DEVIATION REQUEST AND DECISION FORM

(Judge Orr Deviation)

Project Name : Judge Orr Eastonville Commercial Center
Schedule No.(s) : 4232302003
Legal Description : LOT 1177 WOODMEN HILLS FIL NO 10

Deviation Exhibit 1

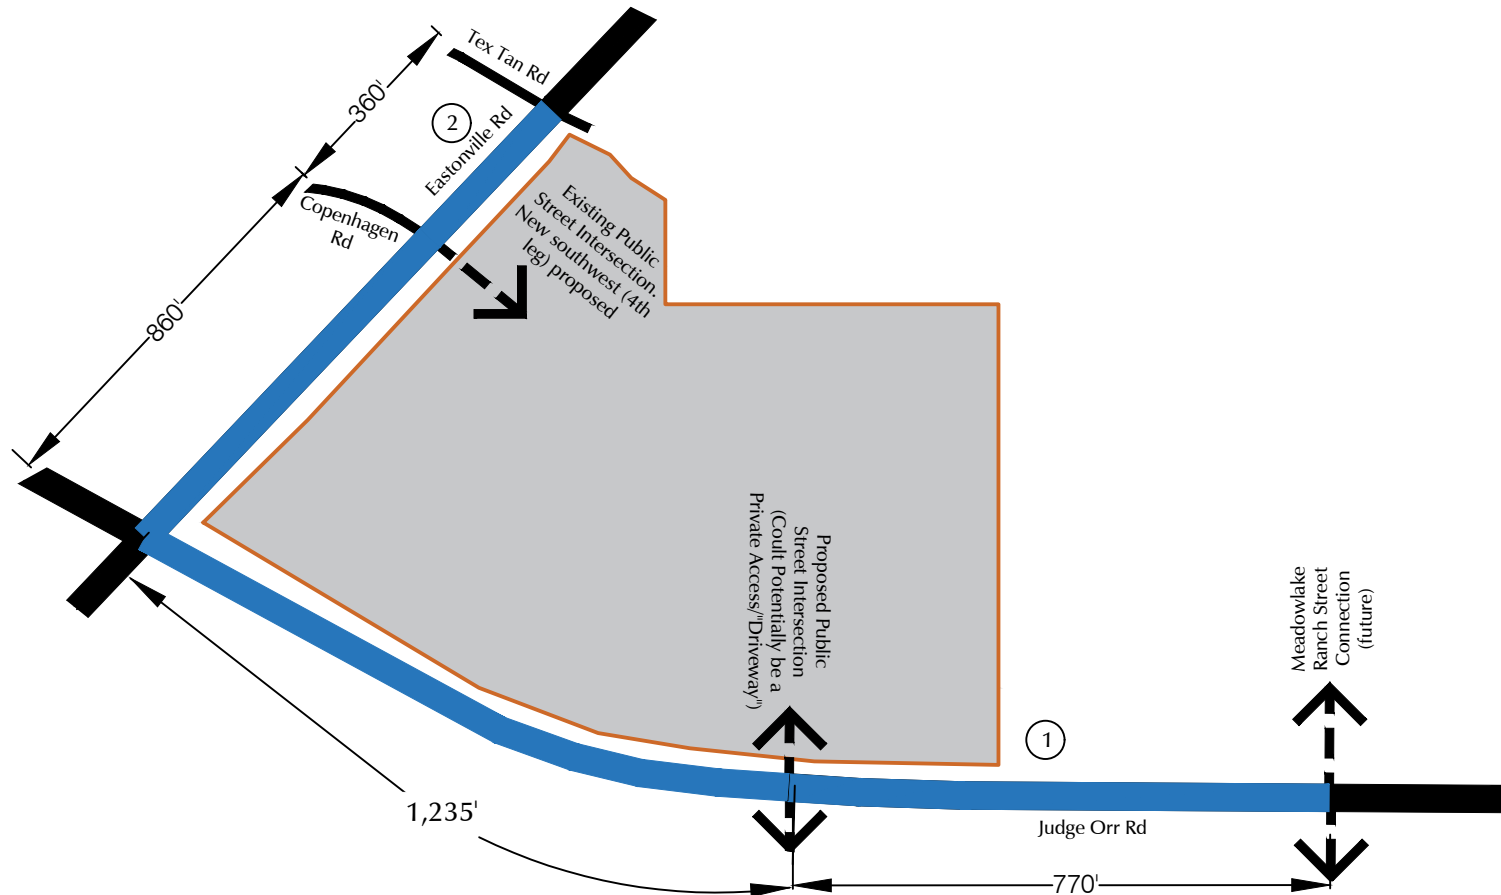
The proposed access spacing is less than one-quarter mile to the east and west along Judge Orr Road.

- The centerline spacing of the proposed south site access (which would potentially be a public street intersection) would be 1,235 feet east of the Judge Orr Road/Eastonville Road intersection (see Deviation Exhibit 1)
- The centerline spacing of the proposed south site access (which would potentially be a public street intersection) would be 770 feet west of the proposed Meadowlake Ranch/Judge Orr Road intersection (see Deviation Exhibit 1)

- The length of frontage along Eastonville is less than ¼ mile.
- The frontage along Judge Orr is greater than ¼ mile. However, there are only 770 feet between Eastonville and the planned access for Meadowlake Ranch to the east. Therefore, there would be less than ¼ mile either to Eastonville to the west or Meadowlake Ranch to the east.

- Due to the existing linear distance between Eastonville Road and the (future) Meadowlake Ranch site access to the east, it is not possible to place an intersection on Judge Orr Road ¼ mile from both aforementioned intersection locations. The intersection has been placed approximately halfway between the two, while taking into consideration horizontal curve constraints on Judge Orr Road to the west of the proposed south site access. The proposed intersection could be designed to meet *ECM* sight-distance and grading requirements, while cooperating with adjacent development.
